**ON-SITE SEWAGE DISPOSAL SYSTEM
 HOWARD COUNTY HEALTH DEPARTMENT
 BUREAU OF ENVIRONMENTAL HEALTH**

SUBDIVISION: Homewood Crossing LOT NUMBER: 62

ADDRESS: 11200 Independence Way PROPERTY OWNER: Toll MD III LP

WALL CHECK
HOMEWOOD CROSSING
PHASE 2
PLAT No. 18244
LOT No. 62

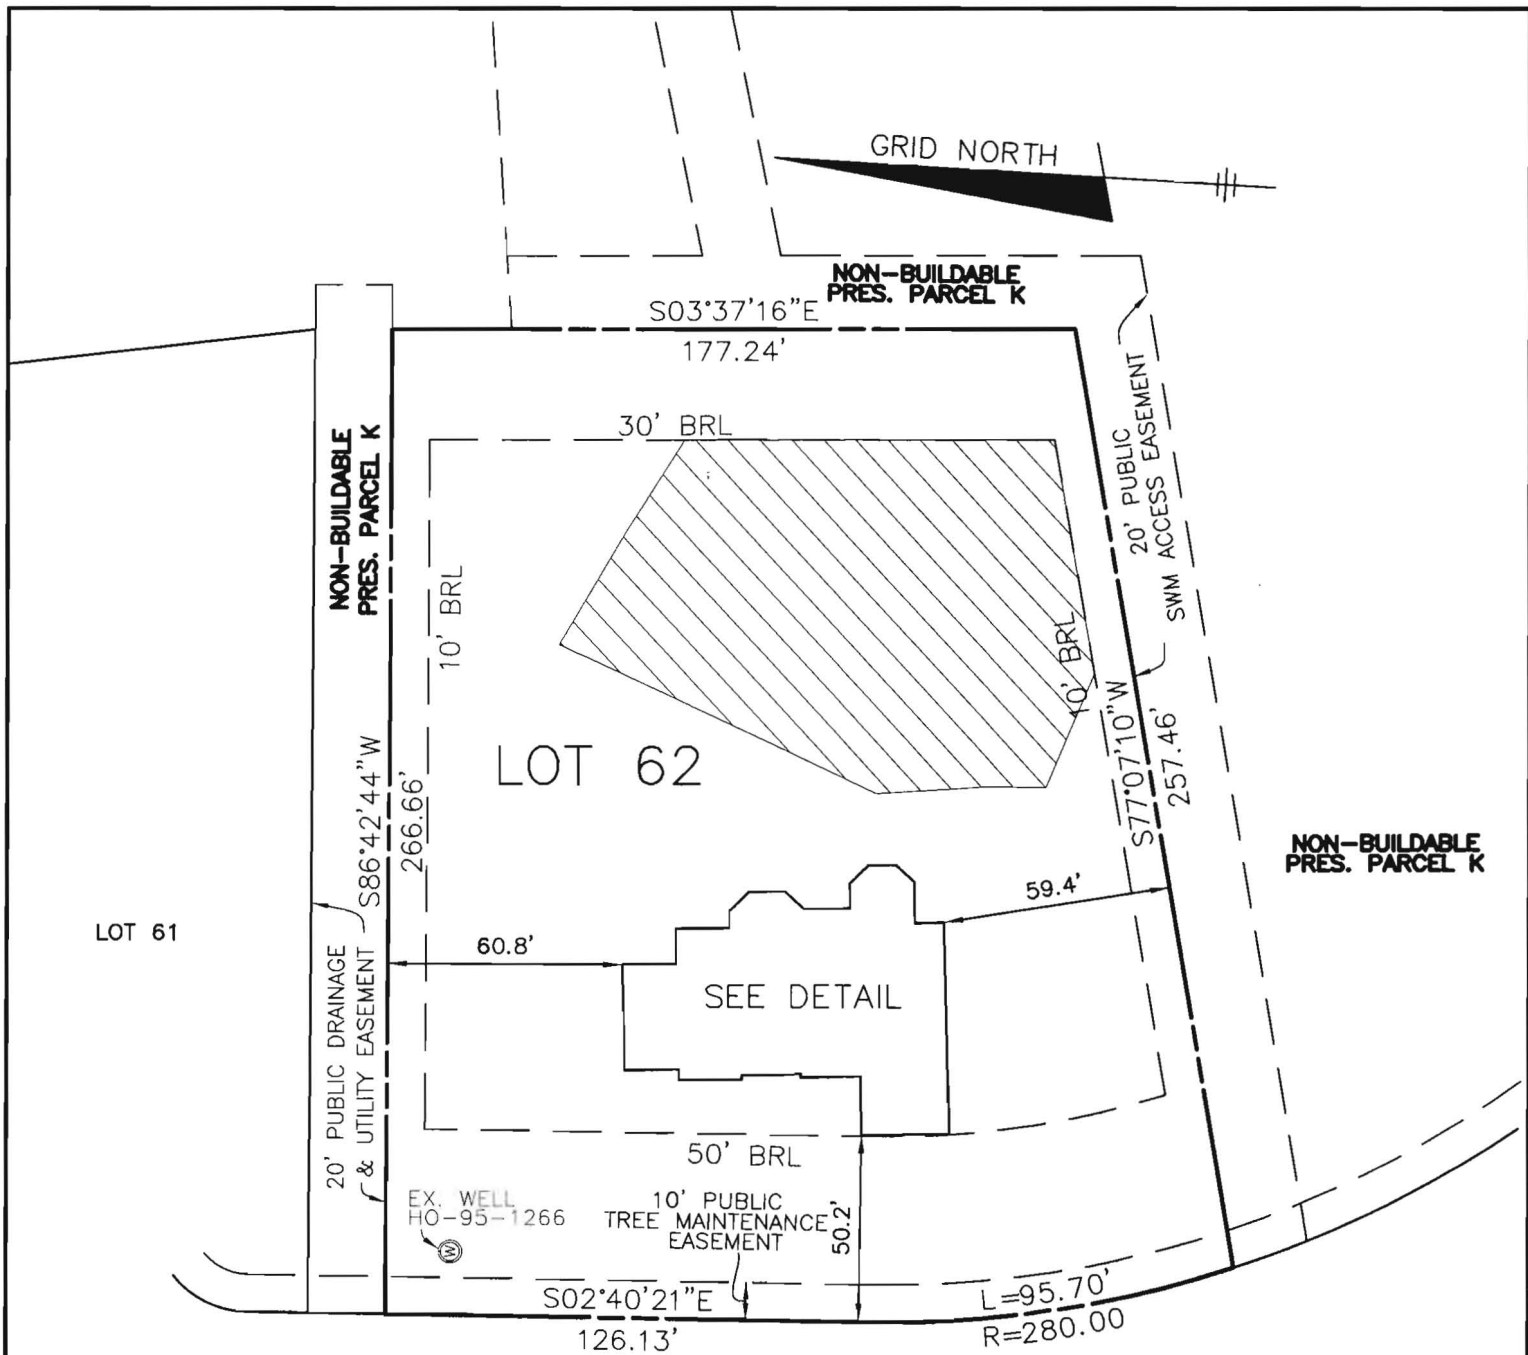
HO-95-1266
 PRE-CONSTRUCTION 6/5/08 Keep tank out of swale. Set Dbox ~10' down from high corner stake. Install a 45', 55', 45' trenches on constant. Work around trees as needed. (RW)
 6/6/08 Tank and Dbox set. Holes were made. OK to cover. No trenches dug. (RW) 6/7/08 System complete as instructed. OK to backfill. (RW)

FOUNDATION DETAIL
SCALE: 1" = 30'

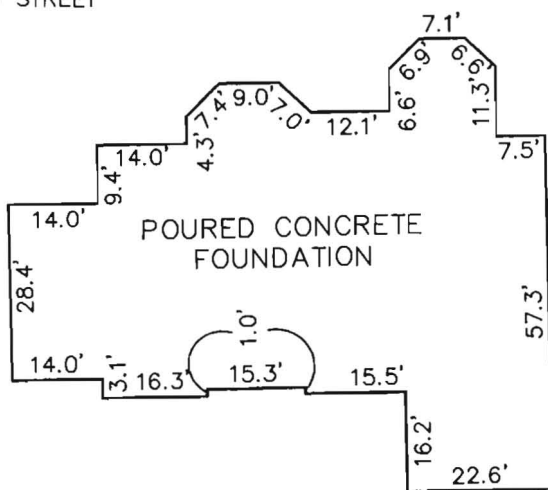
*Wall check
ok
5/14/08
SS*
